UNITED STATES PATENT AND TRADEMARK OFFICE

APPLICATION NO.	FILING DATE	FIRST NAMED INVENTOR	ATTORNEY DOCKET NO.	CONFIRMATION NO.
09/822,154	03/30/2001	Robert A. Immerman	IN0191US (#90067)	6306

Office Action Summary

FAOM after RCE Filed

Des. 121,813

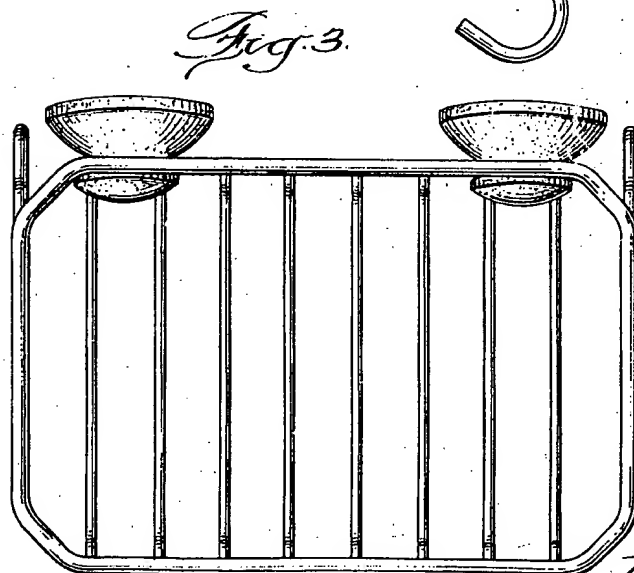
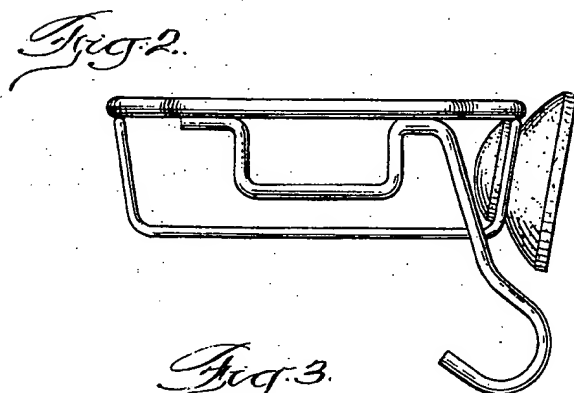
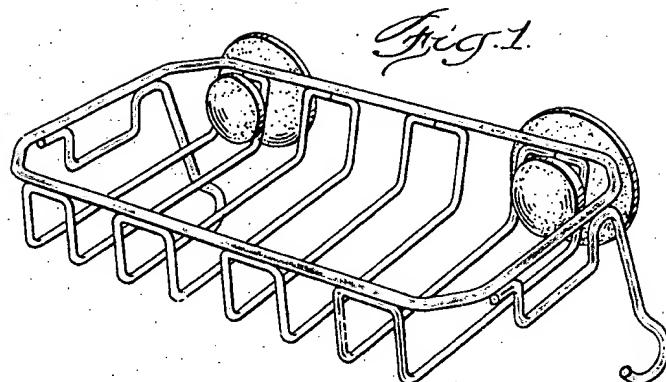
Claim 1, 6-8, 11, 16-19 are rejected under 35 U.S.C. 102(b) as being clearly anticipated by Isenburg (Des. 121,813). See attached drawing for more details. Isenburg shows a first pair of horizontal, generally parallel, rigid wires (in yellow), a second pair of non-parallel rigid wires (in orange) transverse to and engaging the first pair of rigid wires defining a generally rectangular opening for receiving the head of a suction cup and for retaining the neck in the opening, and two fastening arrangements that hold the second pair of wires attached to the fixture (in blue). The suction cup has a compressible head attached to a neck, the neck is attached to an engagement member, the head is insertable into the opening and the neck is retained in the opening.

Regarding the applicant's argument towards the Isenburg reference, the examiner's rejection stands as the examiner disagrees with the applicant's argument that the wires do not form a generally rectangular opening. The first wires in yellow and the second wires in orange form a generally rectangular opening in a 3-dimensional sense. The

applicant states that the orange wires are not parallel, but the claims do not claim that the second pair of wires are parallel, in fact they claim that they are not parallel. The applicant argues that each of the orange wires do not engage each of the yellow wires as there is one orange wire that only engages other orange wires. The examiner submits that it is only a portion of the orange wire that engages the other portions of the orange wire. The ends of the orange wire do in fact engage each yellow wire and therefore meets the claim. The applicant argues that the wires are slid over the suction cup instead of compressing the suction cup but as seen from the figure, the diameter of the head is larger than the width of the opening so it is inherent that the head is compressed in order to position it between the wires. Also the flexibility and ability to compress a suction cup is well-known in the art. In Isenburg, a bottom wire placed directly below the suction cup is not needed as gravity alone, as well as the weight of any items placed on the fixture and the diameter of the suction cup being larger than the opening will cause suction cup to remain in place. Examiner submits that any nick or tear in the neck of the suction cup will cause any suction cup to fail, or at least be weaker, not only in the Isenburg reference as submitted by the applicant.
